Release Note

Edgecore EAP104 Release v12.4.3

Document # EAP104-v12.4.3-1102-f9b9b8034

Enhancement from v12.4.1-1048-f462f4f3

1.1 Support SSID Isolation

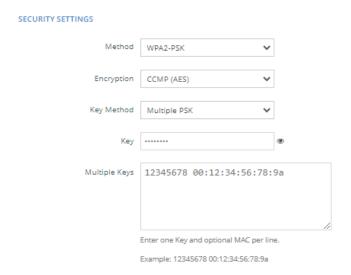
Support SSID Isolation on the radio 5/2.4GHz of wireless page

1. SSID Isolation: Enabled or disabled SSID isolation. If enabled, clients are isolated on different SSIDs but the same radio cards.
